EQUIPMENT/FURNISHINGS - FORWARD DIVIDER DOOR/GARMIN INTERFACE

700 (Citation Longitude)

SB700-25-02
Page 1 of 6

Figure 1. Divider Door/Garmin Interface Wiring Modification (Sheet 1)

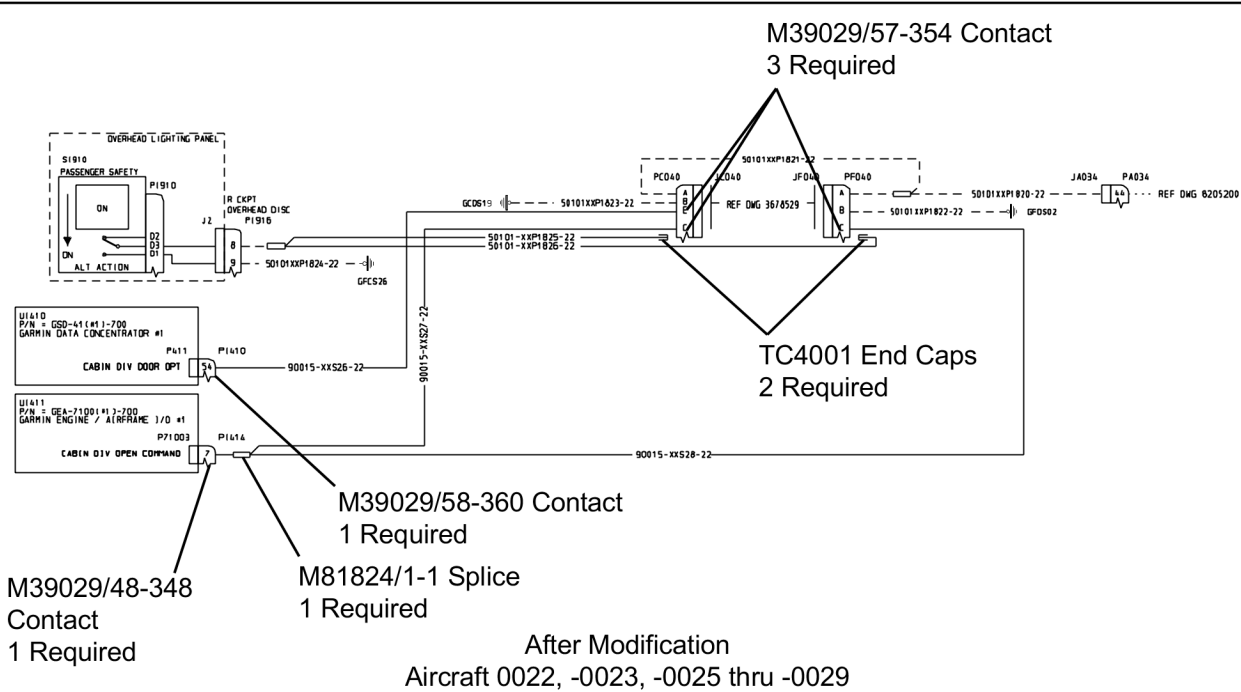
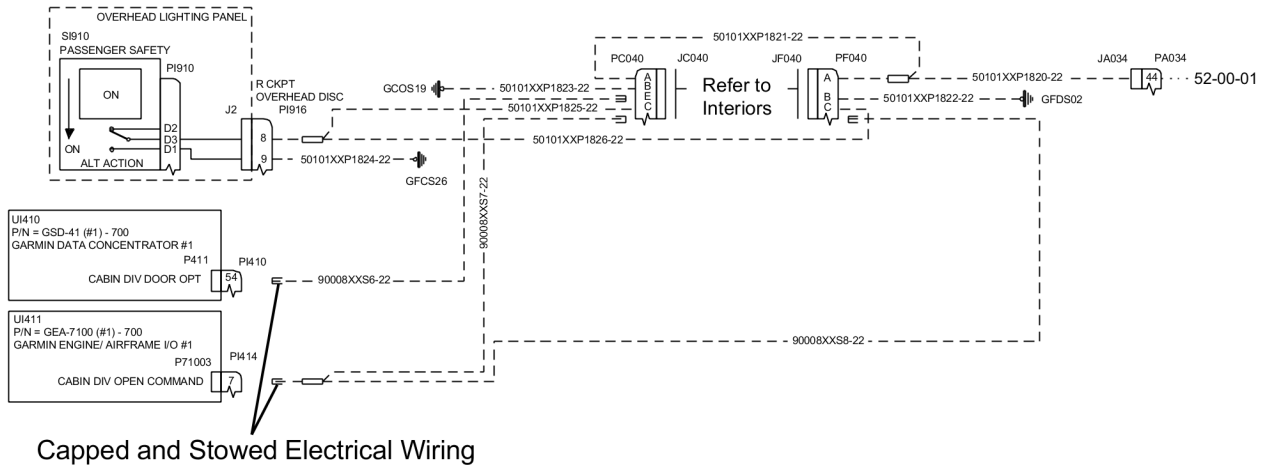
2. (Refer to Figure 1, Sheet 1.) Aircraft -0022, 0023 thru -0029, do the wiring modification per wire diagram.
 - A. After wiring modification is complete, Using an indelible marker, identify circuit breaker HZ233 located on the right DC power junction box circuit breaker placard as 'FWD DIVIDER'.

Figure 1. Divider Door/Garmin Interface Wiring Modification (Sheet 2)

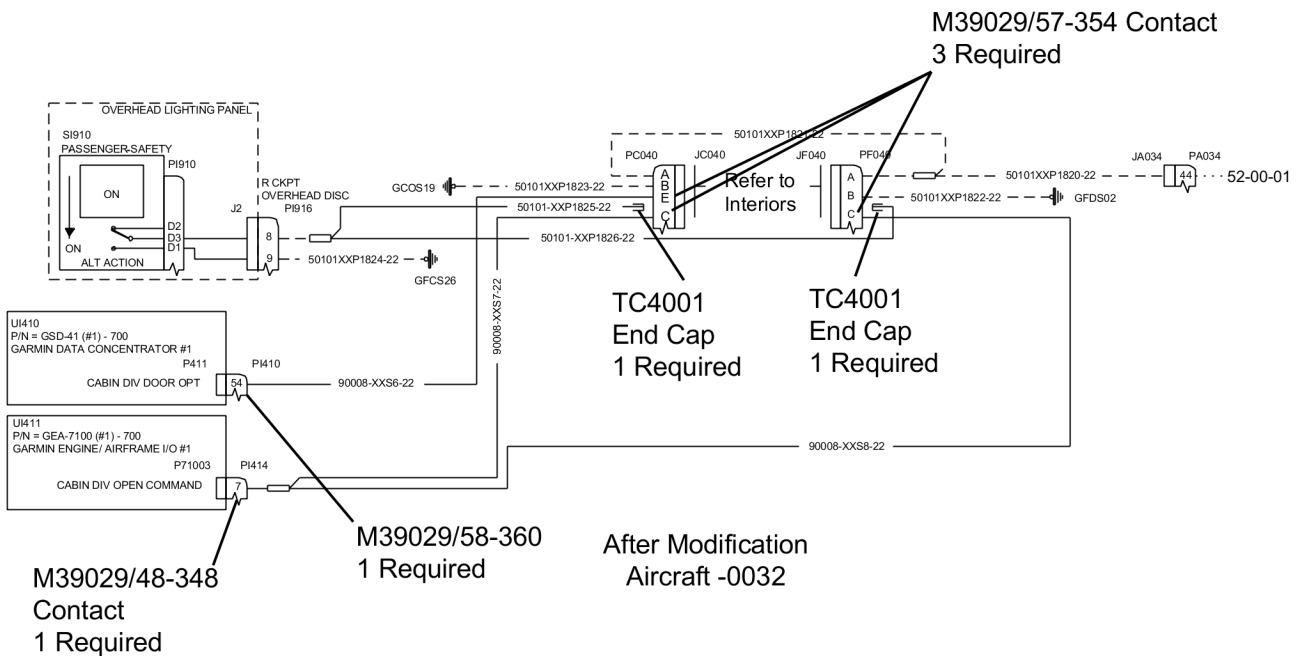
3. (Refer to Figure 1, Sheet 2.) Aircraft -0032 do the wiring modification per wiring diagram.
 - A. After wiring modification is complete, Using an indelible marker, identify circuit breaker HZ233 located on the right DC power junction box circuit breaker placard as 'FWD DIVIDER'.
